# TRUCK, RADIO, MEDIUM, SR D11/R230, 1-TON, 4x4, AUSTIN, K9

#### TECHNICAL HANDBOOK - MODIFICATION INSTRUCTION

# SUB-TITLE: Fitting Teleprinter T100/R to Baseboard, teleprinter YB 08193

SUB-TITIE: Removal of canvas trunking between cab and body of vehicle

Fig 1 - Rear retainer assembly

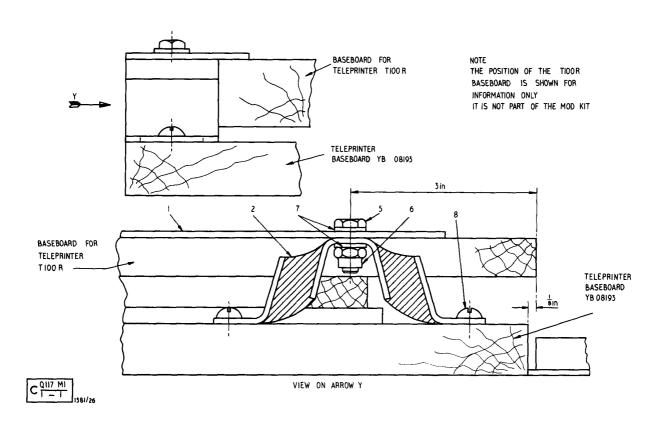
Rear Retainer assembly 1 off (see Fig 1)
Front Retainer assembly complete with fixing screws
2 off (see Fig 2)

- (a) Loosen the screws (Item 5) retaining the vibration dampers to the rear retaining strip and front edge of the retaining strip whoch overlaps the vibration damper facing the front edge of the baseboard YB 08193. Secure the 1.h. damper to the top face of the baseboard flush with the back edge and with the centre of the damper 3 in. from the left-hand edge of the baseboard using two No 12 round head woodscrews (Item 8) (see Fig 1).

Fig 2 - Front retainer assembly

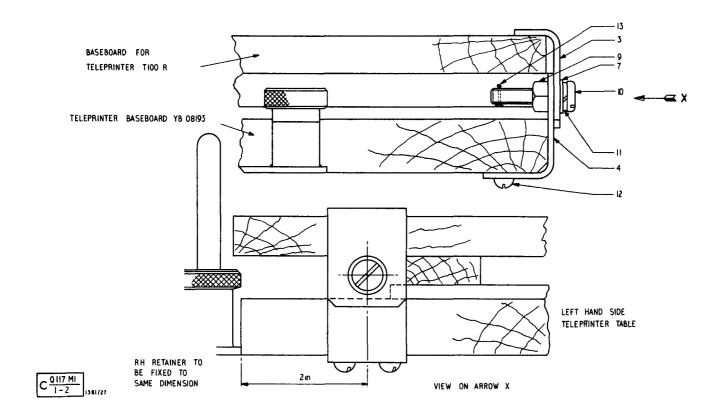
- (e) Fit the front retainer assemblies (one on the l.h. side and one on the r.h. side) to the baseboard YB 08193 using four No 8 woodscrews (Item 12) positioning the retainers so that the centres of the clamping screws (Item 10) is 2 in. from the edge of the baseboard (see Fig 2).

Fig 1 - Fitting cover plate to bulkhead body

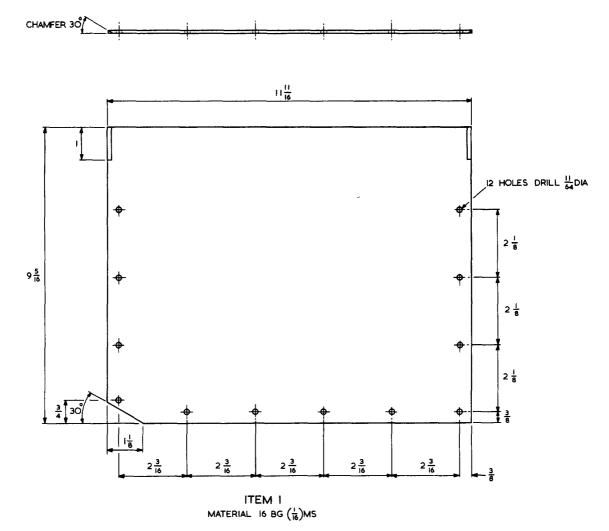
- (f) Carry out the drilling sequence detailed in Fig 1 (notes 1-6) for securing cover plate in position by means of self-tapping screws
  - Remove cover plate and apply sealing compound to underside of cover plate where it is in contact with vehicle body; also apply a liberal amount between weather strip and vehicle skin. Replace over plate and secure with self-tapping screws.

- ! 12 HOLES AT B DRILL No 25 (O·149) THROUGH EXTERIOR PANELLING AND FRAME MEMBERS
- 2 4 HOLES AT C DRILL No 25 (O-149) THROUGH BEADING STRIP, COVER PLATE, EXTERIOR PANELLING AND FRAME MEMBER OPEN OUT HOLES IN COVER PLATE AND BEADING STRIP TO 164 DIA CSK AT 90° TO 56 DIA IN BEADING STRIP ONLY
- 3 HOLES AT D ARE EXISTING IN BEADING STRIP EXTERIOR PANELLING AND FRAME MEMBER DRILL COVER PLATE  $\frac{11}{64}$ DIA
- 4 IN POSITIONS AT B 12 SCREWS SELF-TAPPING No 8 ×  $\frac{1}{2}$  in LONG SLOTTED ROUND HEAD (PART OF ITEM I)
- 5 IN POSITION AT C 4 SCREWS SELF -TAPPING No 8 ×  $\frac{3}{4}$  in LONG SLOTTED RAISED HEAD (PART OF ITEM I)
- 6 DIMENSIONS IN INCHES
